**Office for
Nuclear Regulation**

Step 4 Assessment of Radioactive Waste Management for the UK HPR1000 Reactor

Assessment Report ONR-NR-AR-21-023
Revision 0
January 2022

Figure 1: ICIA Winding Process Summary from (Ref. 61)

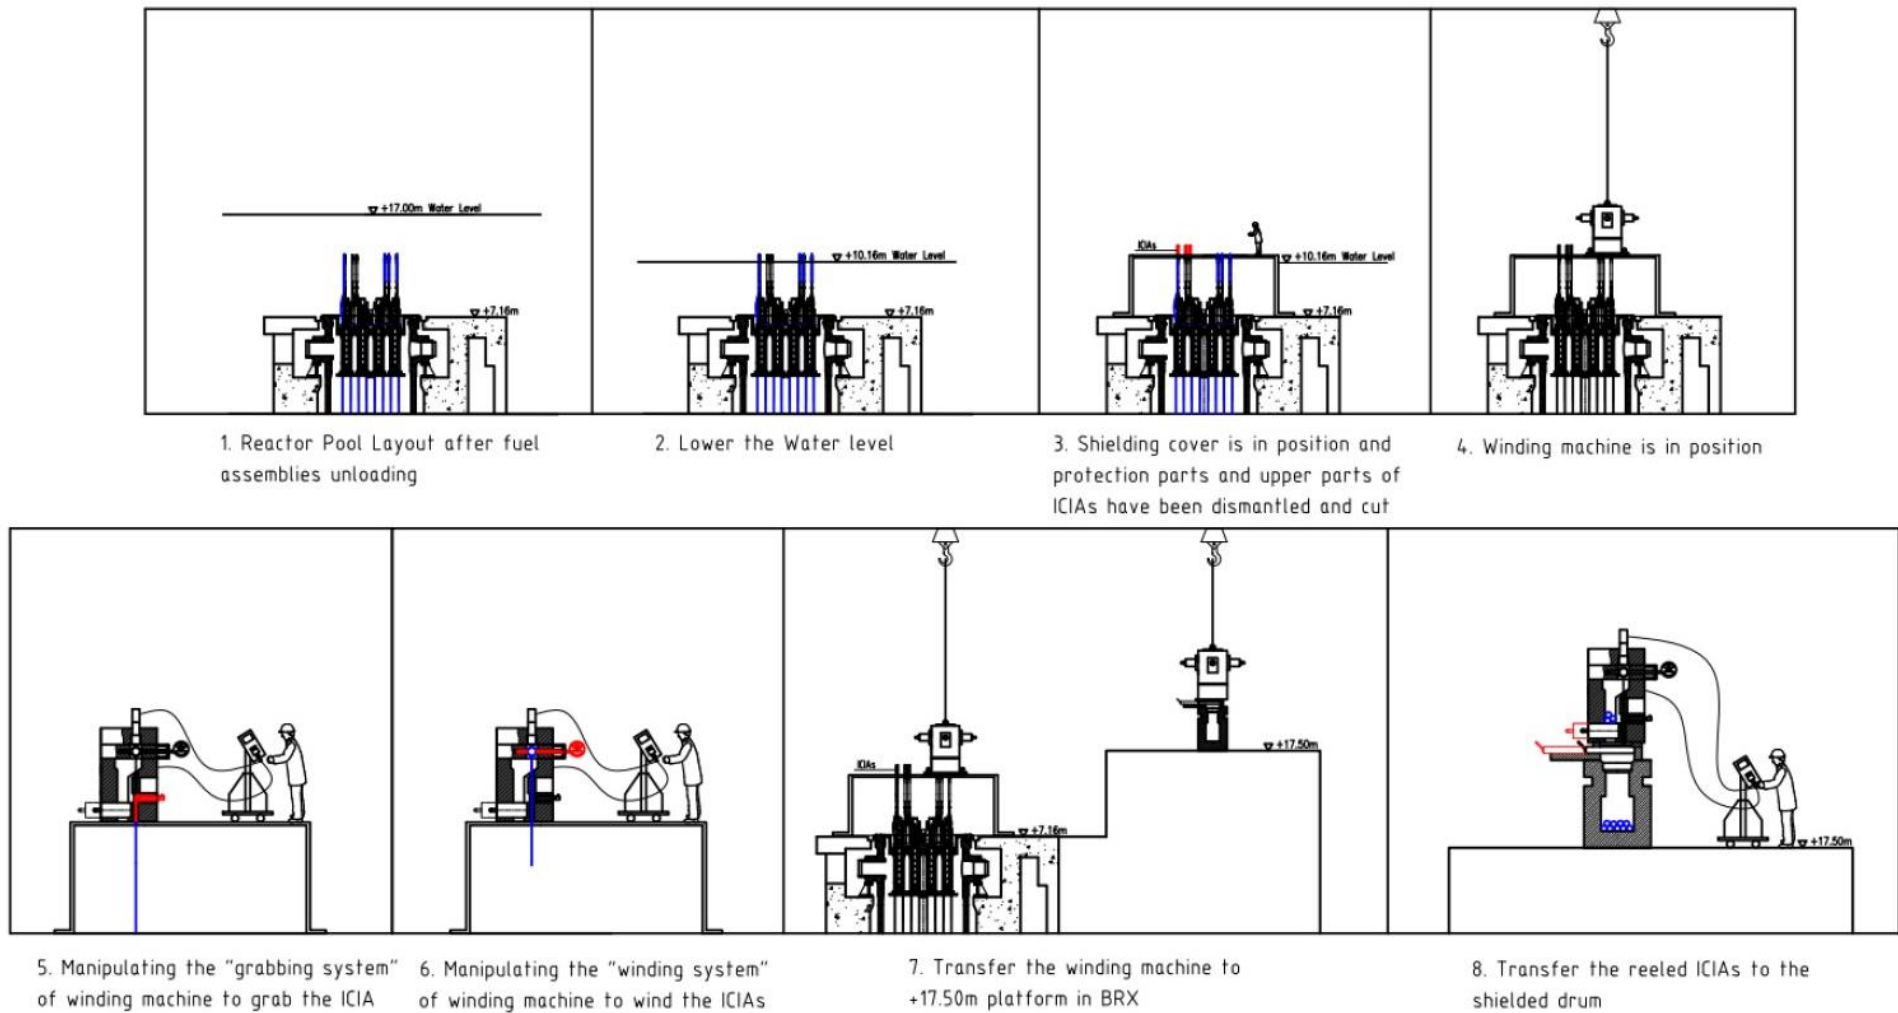
associated operations to be novel in the UK context and did not align with practices adopted by UK licensees for management of ICIAs.

157. The RP's optioneering (Ref. 61) considered and discounted the following options:
- Using the SFP for storage of intact ICIAs. The RP provided evidence that the transfer of intact ICIAs is not compatible with the transfer facilities between the Reactor Building and the SFP due to size constraints. The transfer facilities are designed to accommodate SFAs up to 4.3m long, whereas the ICIAs are up to 12m long. In addition, the water level in the reactor pool, which occupies the space above the reactor cavity, is insufficient to provide adequate shielding of the higher source term region of ICIAs during extraction of intact Type i&ii ICIAs.

161. In my opinion, the RP's safety case provides adequate evidence that the winding machine is the only reasonably practicable management strategy for the retrieval of waste ICIA, considering RGP, OPEX and the constraints within the UK HPR1000 design. In my opinion, the winding equipment is novel and therefore is not consistent with RGP in the UK. However, the evidence provided by the RP is consistent with regulatory expectations to articulate why there are no further reasonably practicable improvements that could be implemented within the generic UK HPR1000 design without significant modification to the Reactor Building. Therefore, in my opinion, the strategy for the management of ICIA represents the ALARP outcome for the generic UK HPR1000 reactor design.

Figure 3: Spent Filter Cartridge Change Machine Shielded Cell, Nuclear Auxiliary Building

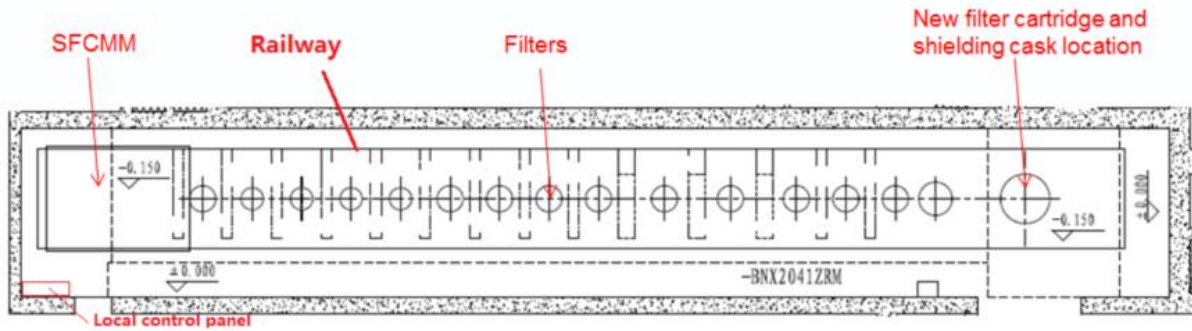
307. Overall, taking into consideration the TSC's and my assessment, I consider the lack of functional requirements of the SFCCM and SFRTD does not align with RGP, or with ONR's expectations, in the context of the relatively high hazards associated with the spent filter cartridges. I have raised Assessment Findings AF-UKHPR1000-0181 and AF-UKHPR1000-0182 to address the shortfalls identified and ensure the licensee provides adequate evidence against sub-claims 3.3.11.SC23.1, 3.3.11.SC23.2 and 3.3.11.SC23.5 for the two filter cartridge change machines.

Figure 4: Spent Filter Replacement and Transfer Device (SFTRD) in the Radioactive Waste Treatment Building.

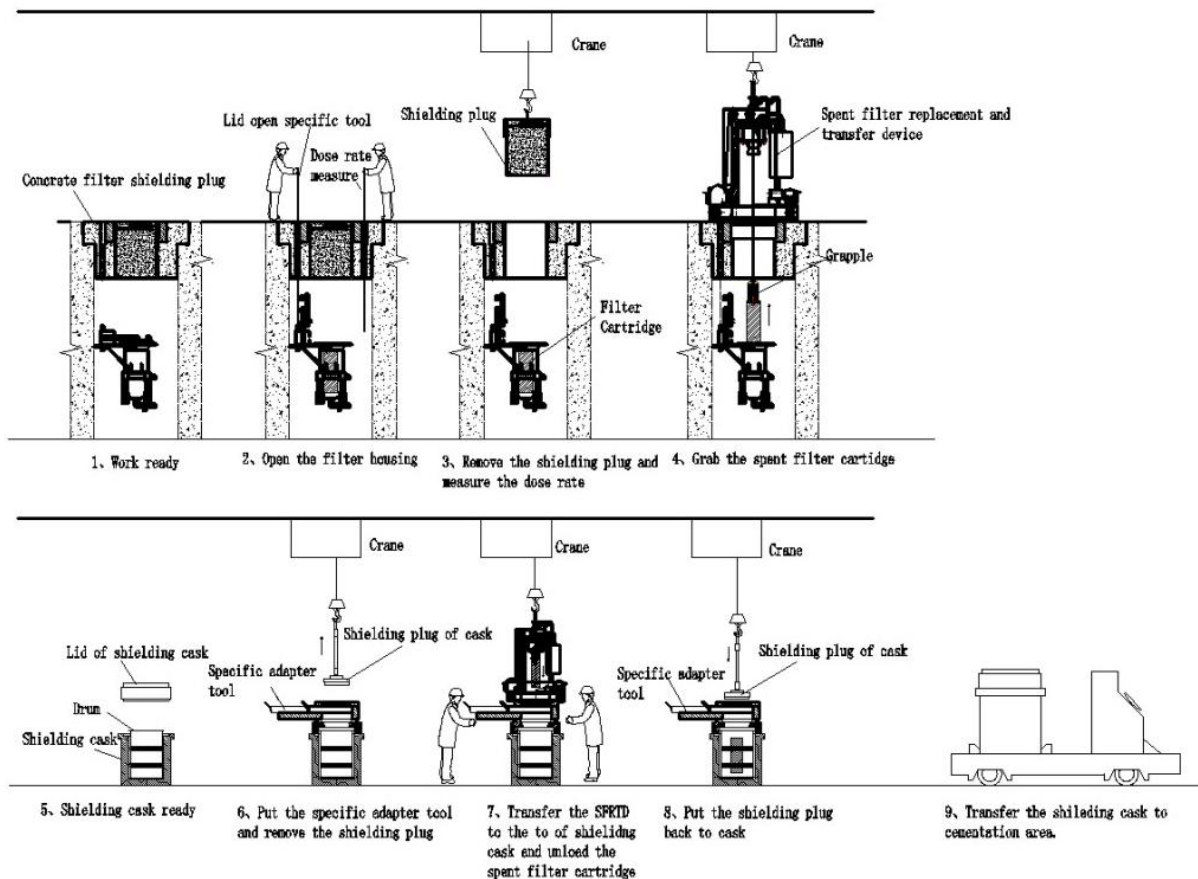
- For the SFRTD, I have raised a similar Assessment Finding to that for the SFCCM, AF-UKHPR1000-0182, for the licensee to provide evidence that the detailed design of the SFRTD, relevant to containment and contamination controls, reduces the risks so far as is reasonably practicable, for both normal operations and fault conditions. I consider the lack of arguments and evidence in the safety case, to justify why the confinement (containment) function of the SFRTD is not categorised and the SFTRD equipment not classified, is inconsistent with the RP's safety case sub-claims 3.3.11.SC23.1, 3.3.11.SC23.2 and 3.3.11.SC23.5.

Figure 5: Radioactive Waste Treatment Building (+0.00m) WSW Receipt and Treatment Facilities (Ref. 46)

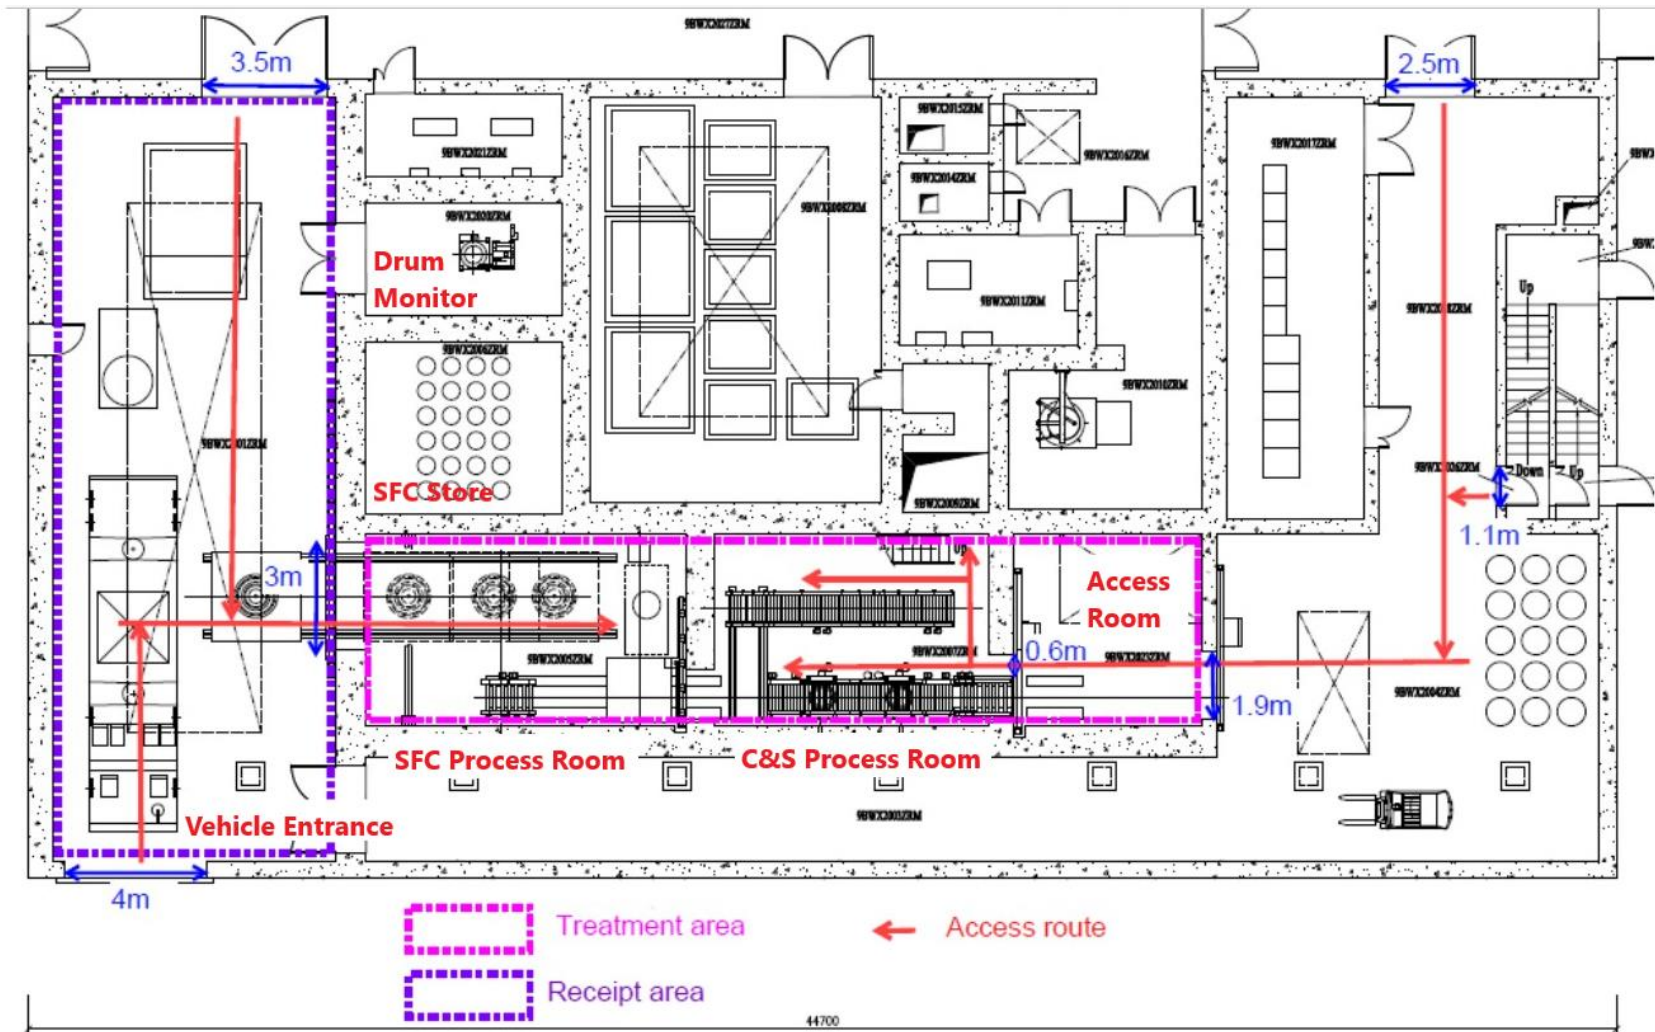
- The spent filter cartridge processing room, the concentrate and sludges processing room, and the access areas are in a linear arrangement, segregated/accessed using shielded doors, as shown in **Figure 5**.

- Layout drawings which highlight access routes are captured in the latest update to the ALARP demonstration for radioactive waste management (Ref. 46). Taking the example in **Figure 5**, the operator access between facilities in the WSW receipt and treatment areas can be through openings as small as 0.6m (60cm). No evidence is provided in the RP's safety case to demonstrate that 60cm is adequate to enable personnel/equipment access for EIMT activities, and therefore it is unclear if the expectations of ONR SAP ELO.1 have been met.

318. Taking into consideration AF-UKHPR100-0183, I consider there is inadequate evidence in the RP's safety case to determine whether the WSW receipt and treatment sub-system meets sub-claims 3.3.11.SC23.1, 3.3.11.SC23.2 and 3.3.11.SC23.5. In my opinion, the licensee should provide adequate evidence to substantiate the sub-claims in addressing AF-UKHPR1000-0183. I consider this finding is consistent with the residual matter identified during the closure of RO-UKHPR1000-0005 (Ref. 87).

Figure 6: ILW Interim Storage Facility Conceptual Design (Ground Floor)

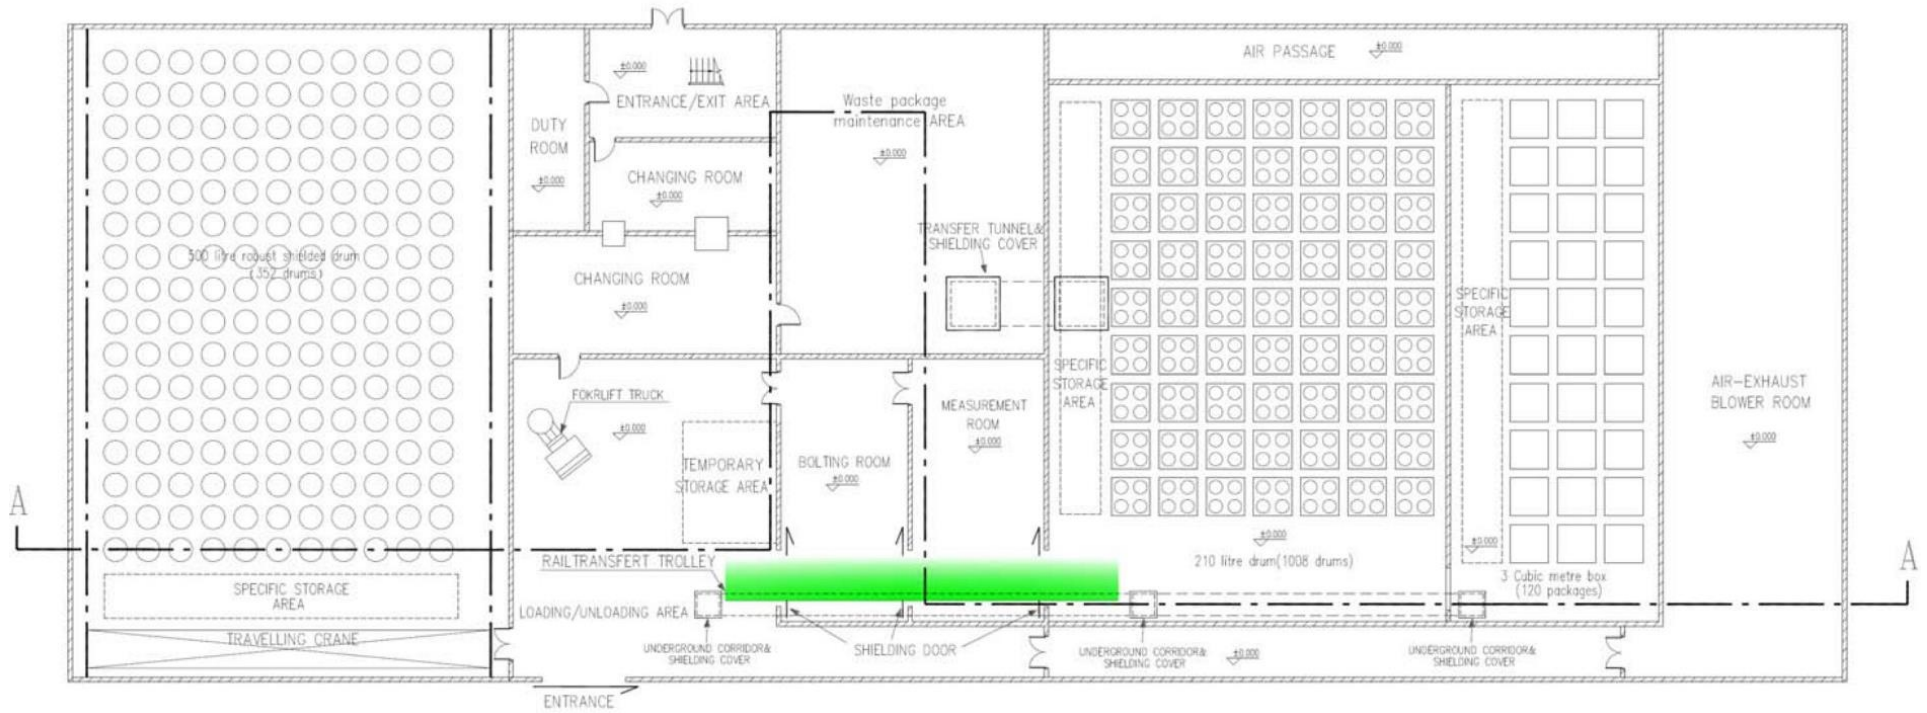
- The conceptual design of the ILW ISF, Figure 6, is consistent with regulatory expectations in ONR SAPs RW.4 and ELO.3 to segregate the radioactive waste packages by type, and thus facilitate subsequent safe management through minimisation of movement. I have identified two Minor Shortfalls, the first related to the sequencing of the import operations and the removal of the 210 litre drum from the shielded cask into the four-drum stillage, and the second for the detailed design to consider the central location of the operation areas to ensure they are consistent with the regulatory expectations in ONR SAP ELO.1.
